## Firmware 2.06.3 bug list:

## List of bugs/improvement requests

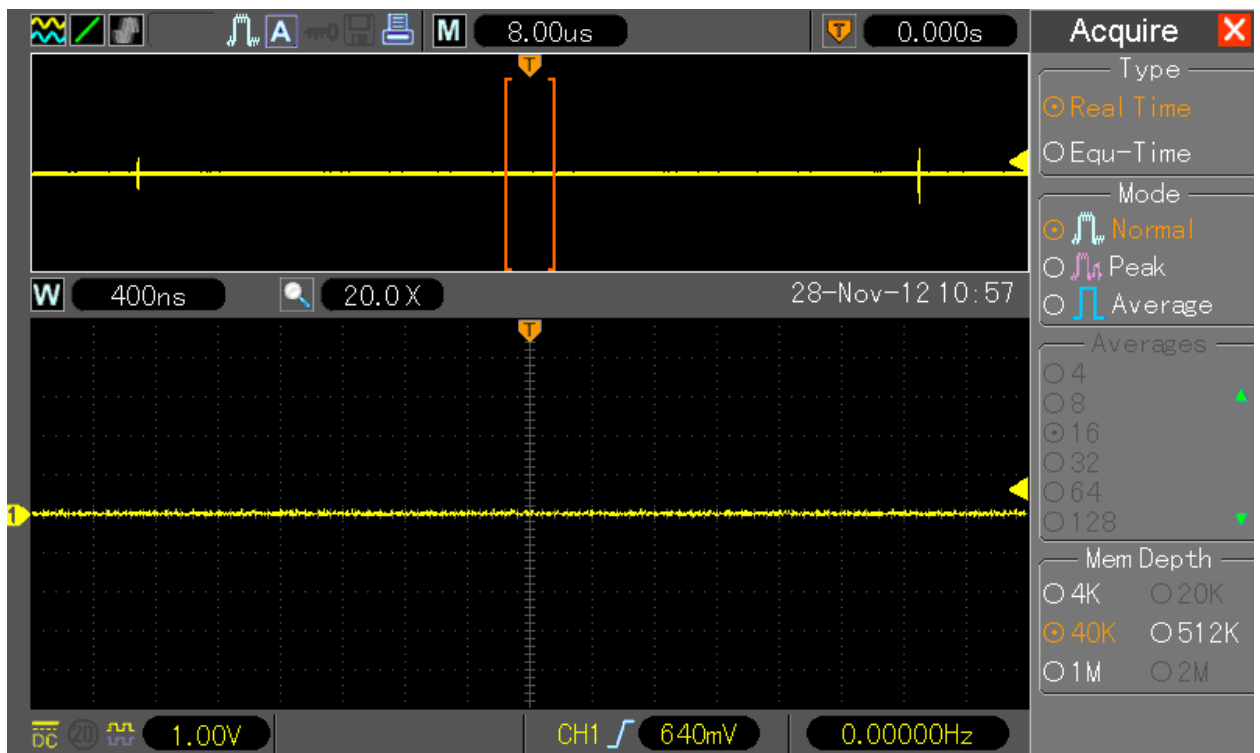
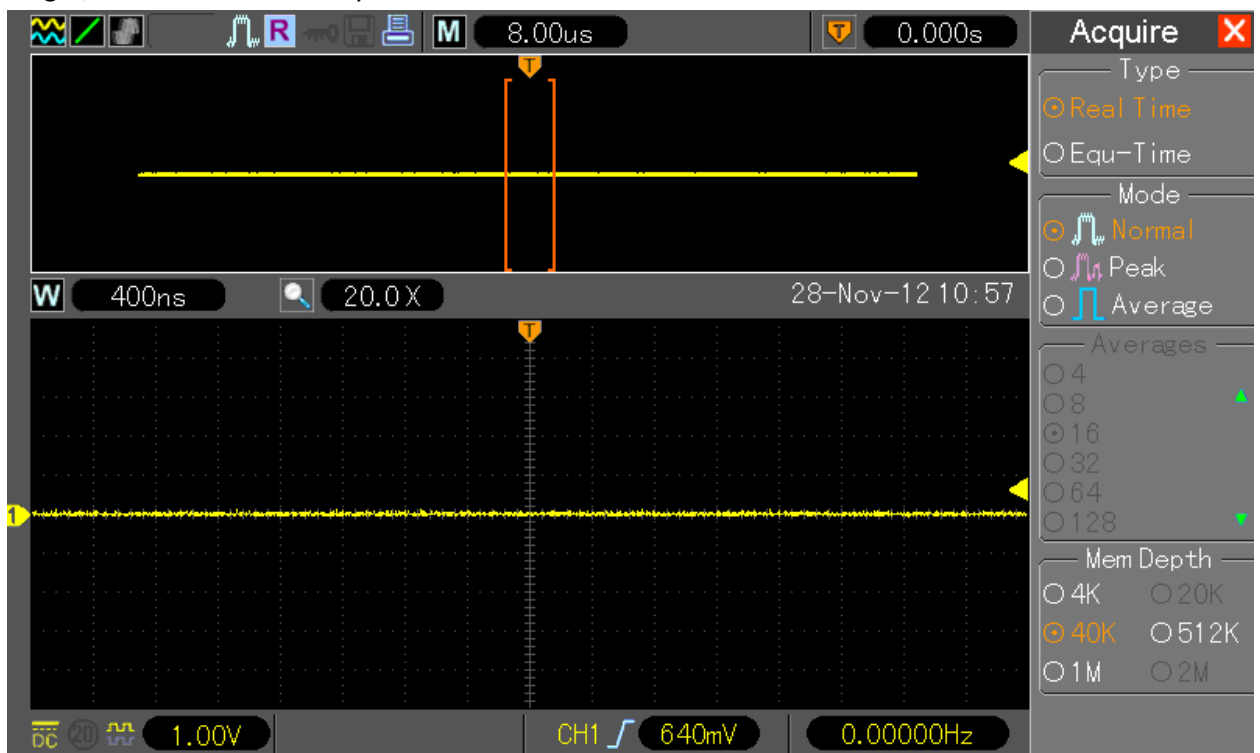
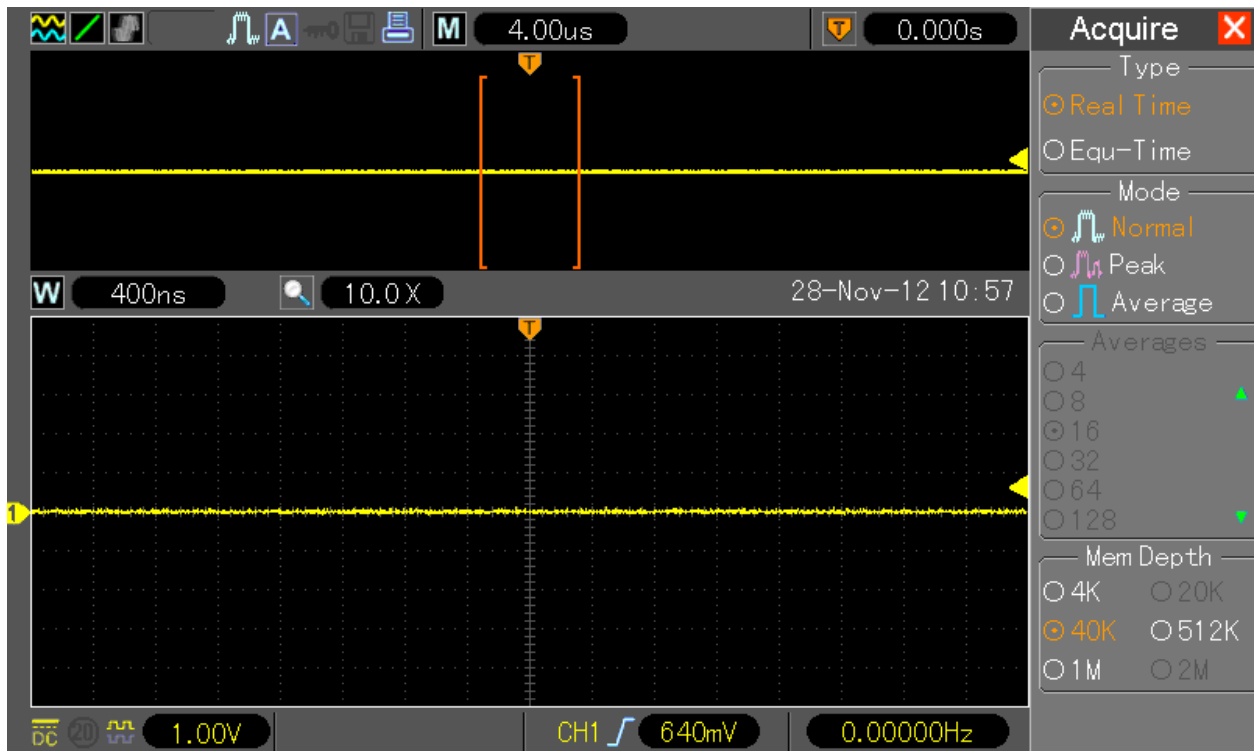
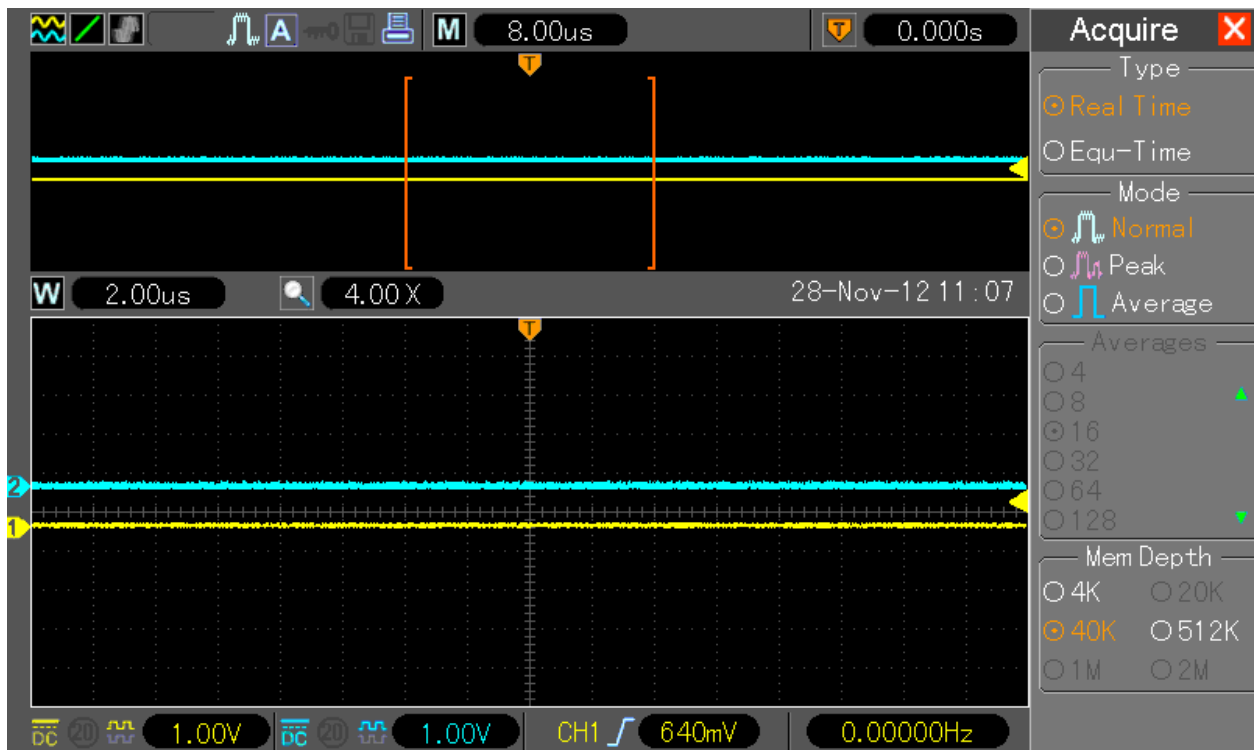
27. While switching from single into dual window mode the main timebase is changing with a wrong factor, e.g. from 200ns/DIV in single into 400ns/DIV in dual window mode. Similar issue in 40k/512k and 1M – in dual window the MTB is twice that high as before in single window mode. Due incorrect timebase the display buffer is showing artifacts on both right and left side of the waveform (end of buffer). Example: CH1 enabled, 40k memory, single window and windows timebase smaller than main timebase, here 400ns/DIV (Main TB is 4us/DIV for 40k)

Now when switching to dual window the Main TB is changing to wrong value (here from 4us/DIV to 8us/DIV – actually it will be always doubled in length) and artifacts from “end of buffer” right and left in top window are shown:

When the Acquisition would be stopped and restarted or Timebase changed one position forth and back (while Main window is focused) the Main TB and displayed data will be fixed to proper length; no artifacts shown anymore:

26. ~~Just ignore it for now; it is interim fw version — for testing only.~~ This is no in production firmware as well, very annoying bug.
27. Switch once focus from minor (bottom window) to major (top window) window by pushing timebase knob down, turn then timebase one position forth and back to get rid of waveform artifacts on left and right side of the waveform.

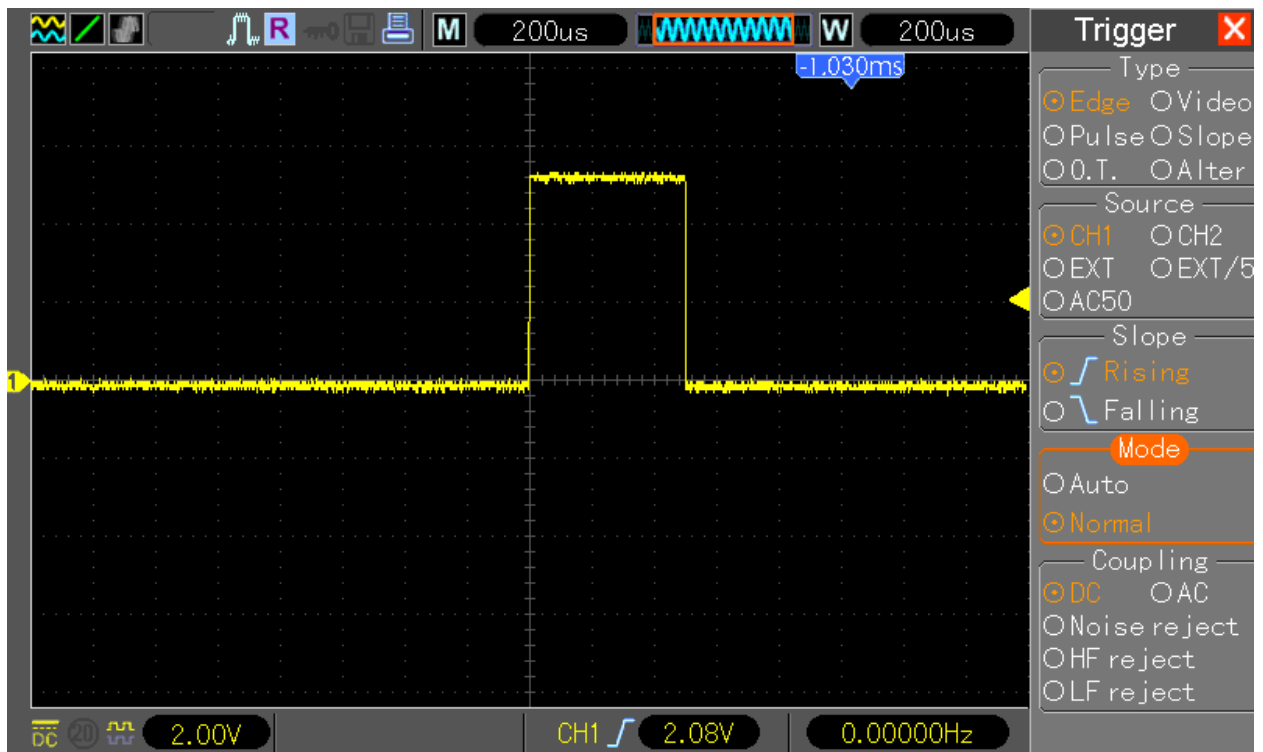
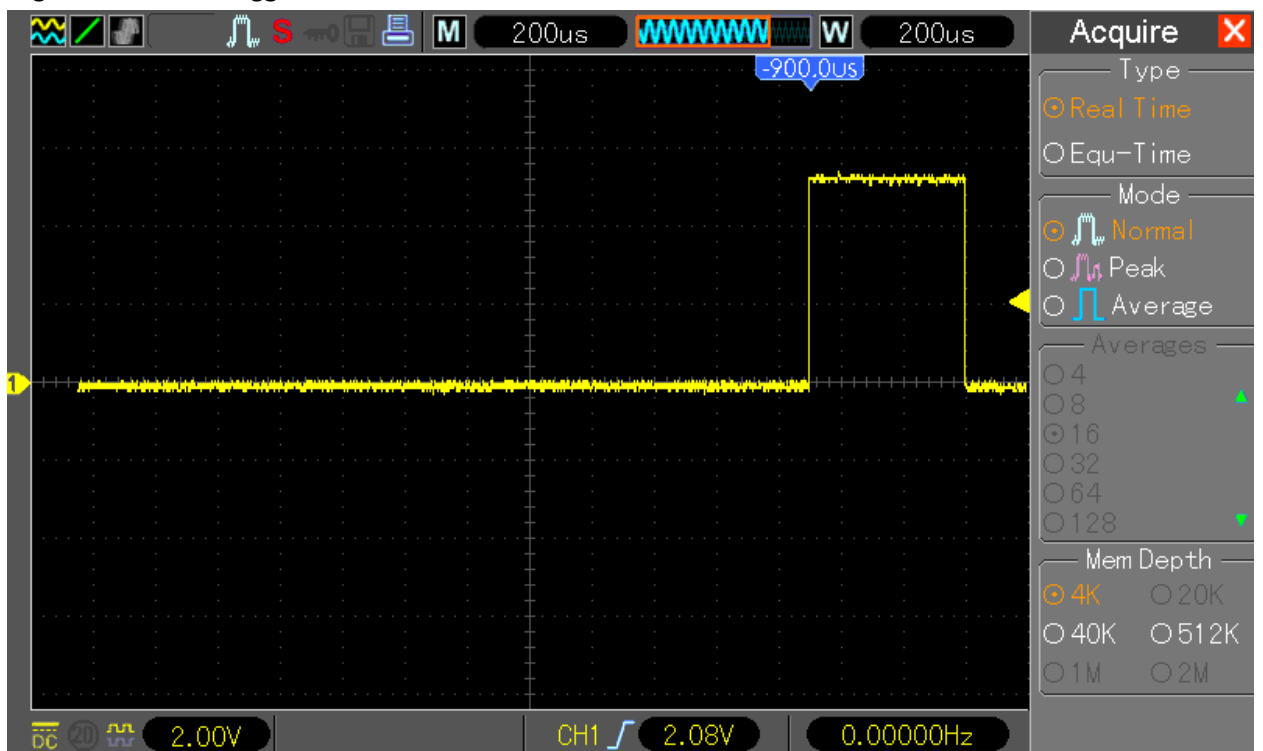
29. Horizontal Position knob not moving display data when trigger in “Armed” position and acquisition in “RUN” mode. To understand this error set following on DSO:

After first trigger event the waveform will appear as following on screen:

Now when you turn the Horizontal position knob to left or right to change the position, the blue trigger indicator is changing as expected, but the already captured waveform is not moving (which is a bug, it make sense to be able to move already captured waveform while waiting for next trigger event. )

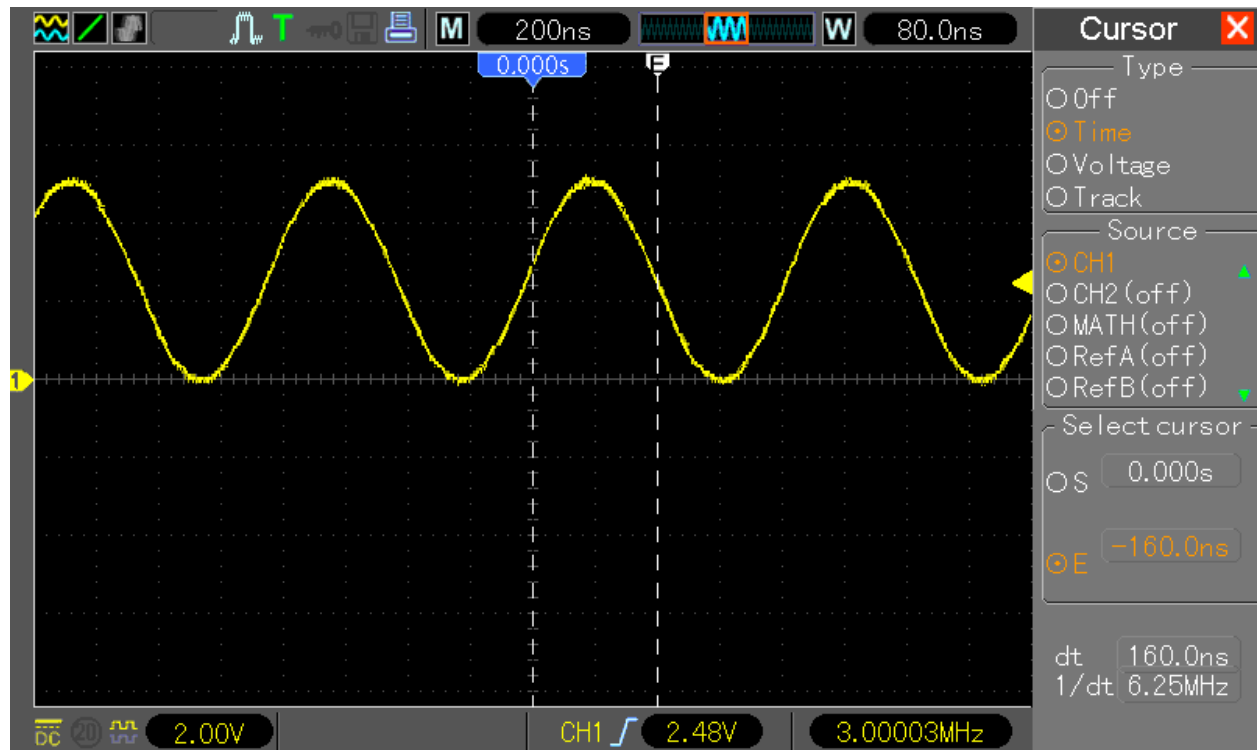
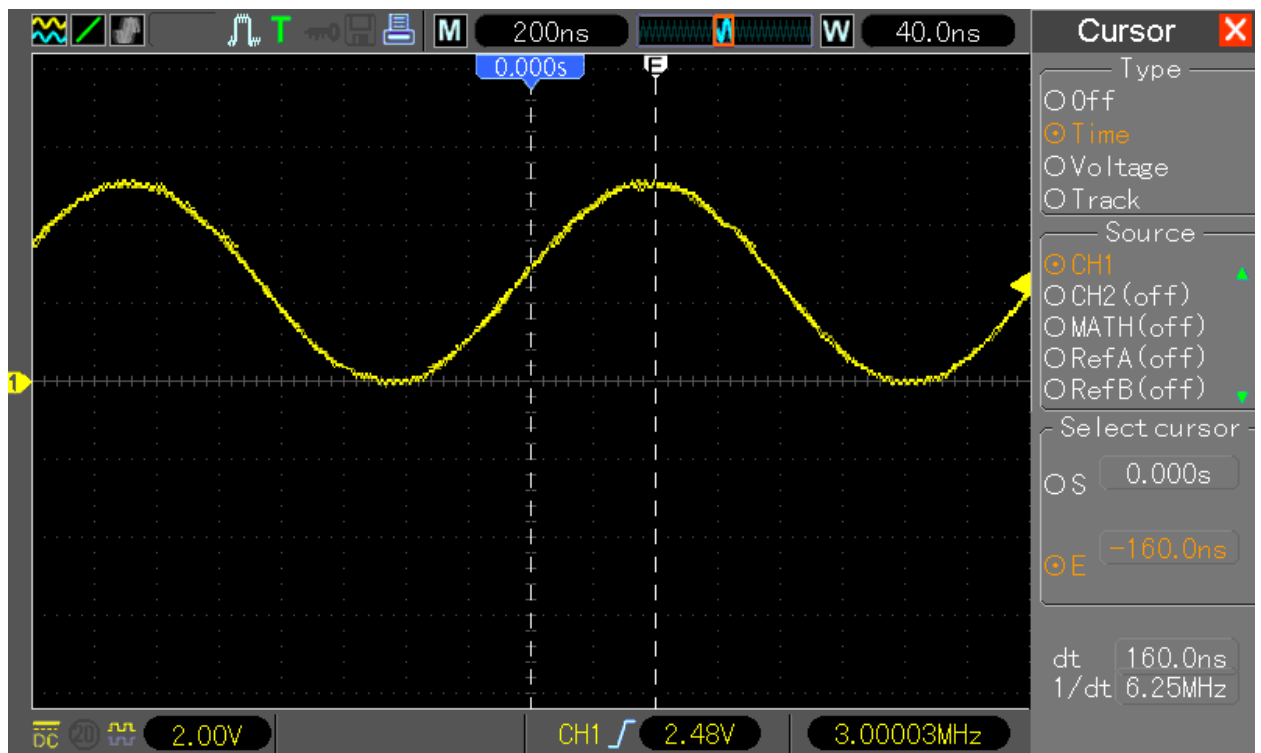
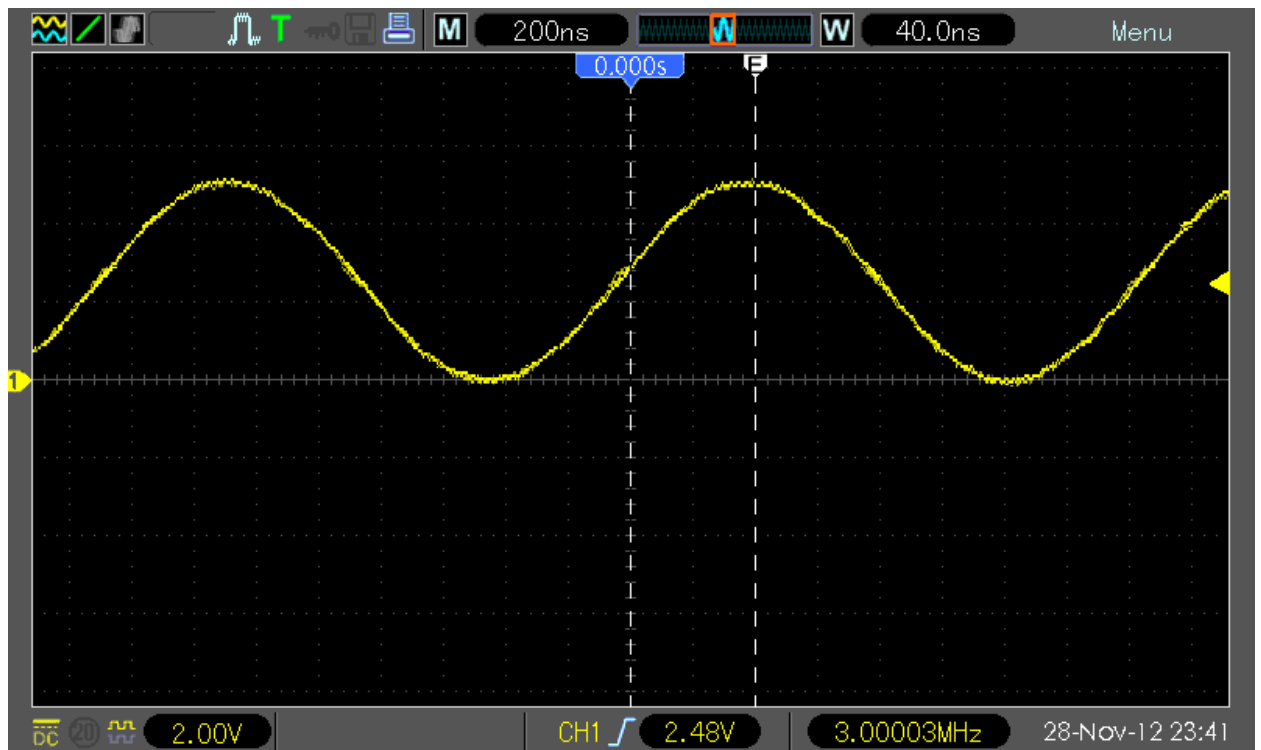
31. In RUN and STOP mode, while changing Timebase the Time Cursor values S and E not refreshing automatically. Any changes to Menu (hide/show with F0), other Knobs (like V0) position or any Buttons (e.g. push Measure button and again Cursor button) is refreshing the S and E values in Menu.

Here example, TB set to 80ns/DIV, cursor S to 0.0ns and E to -160ns:

Then TB changed to 40ns/DIV, but displayed value for E still -160ns:

and enabling Menu again with F0. The E cursor value is now having proper value (-80ns):

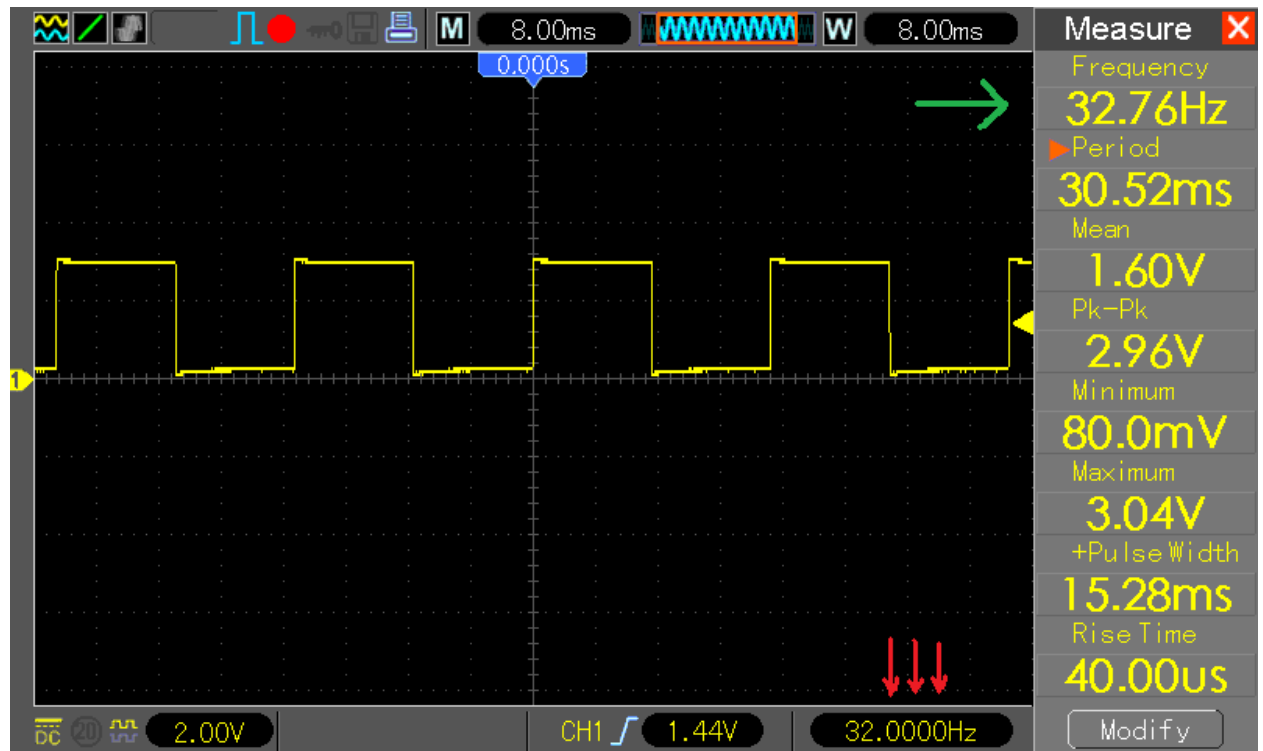
34. CSV Exported data, if MTB from 40s/DIV to 4ms/DIV the amount of samples is wrong as well the displayed MTB value seems to be wrong. Example :  
 4k depth, 4ms/DIV -> CSV shows #timebase= -294967296(ps) and not 4000000000(ps)  
 40k depth, 4ms/DIV -> CSV shows #timebase= -294967296(ps) and not 4000000000(ps)  
 512k depth, 4ms/DIV -> CSV shows #timebase= -294967296(ps) and not 4000000000(ps)  
 1M depth, 4ms/DIV -> CSV shows #timebase= -294967296(ps) and not 4000000000(ps)

**The number -294967296 is nothing else than buffer overflow by 3999999999, -589934592 buffer overflow by 7999999999, etc.**

A quick check of “**SaveWaveDataToCSVFile**” shows the problem source ->

**sprintf “#timebase=%d(ns)\r\n,”** is using **%d** but I think **%lld** was supposed to be there to allow maximum of 40s/DIV to be saved in pico seconds. The “**RecallCSVDataToDispBuf**” need of course to be changed as well to allow read-back of the CSV data longer than 20000000000 ps.

31. ~~Nothing to say here.~~
32. ~~Nothing to say here.~~
33. ~~Nothing to say here.~~
34. We could patch it with Hex Editor from %d to %lld to allow CSV export, but import need to be changed in source code (to work properly), so I would say “let’s wait for official fix”.

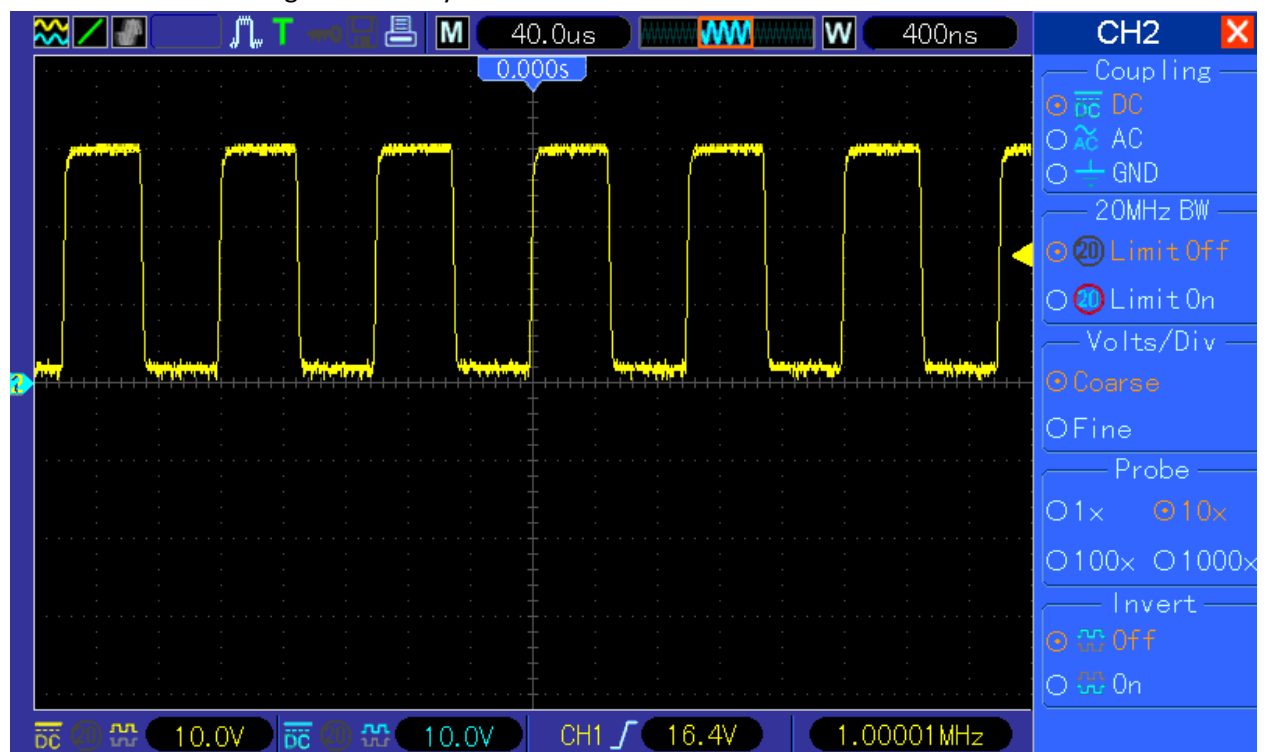
36. If possible change the Frequency Counter to display in mHz resolution when counter value between 1Hz and 99.999kHz (99999Hz). If not possible change displayed value to cut (trailing) zeros, when there is no mHz no need to see zeros instead (e.g 10Hz should be shows as 10Hz and not 10.0000Hz). This might be sometimes very confusing for the user, imagine e.g.

frequency of 32.768Hz – the counter will show 32.000Hz (and Wave measure 32.76Hz).
